SUNDRY NOTICES AND REPORTS ON WELLS
Do not use this form for proposals to drill or to re-enter an abandoned well. Use Form 3160-3 (APD) for such proposals.

8. Well Name and No.
Boquillas 18 Federal #1 (39216)

9. API Well No.
30-015-40266

**Boquillas 18 Federal 1H
30-015-40266
Apache Corporation
May 16, 2013
Conditions of Approval**

Proposed

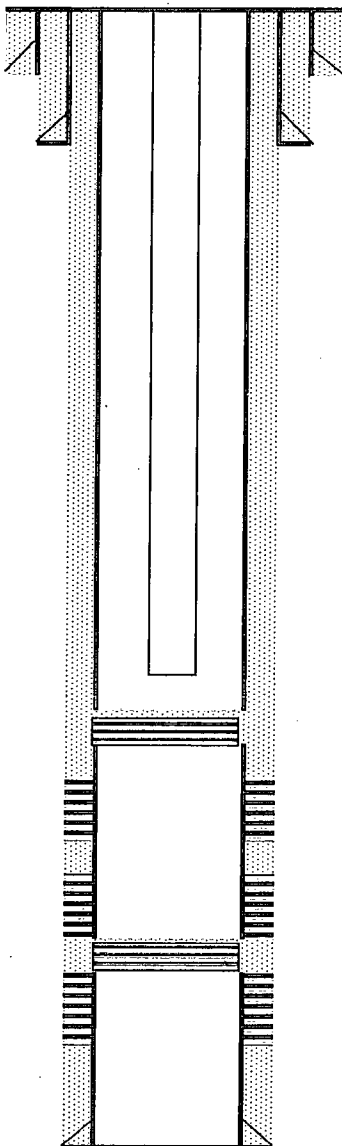
- 1. The operator shall place CIBP at 4250'. Place 142' of neat class C cement on top to seal off the Glorieta Formation. Tag required.**
- 2. Must conduct a casing integrity test before any work can be done. Submit results to BLM. The CIT is to be performed on the production casing per Onshore Oil and Gas Order 2.III.B.1.h. Make arrangements 24 hours before the test for BLM to witness. E-mail Paul R. Swartz pswartz@blm.gov or phone 575-200-7902, if there is no response, 575-361-2822. If no answer, leave a voice mail or email with the API#, workover purpose, and a call back phone number. Note the contact, time, & date in your subsequent report.**
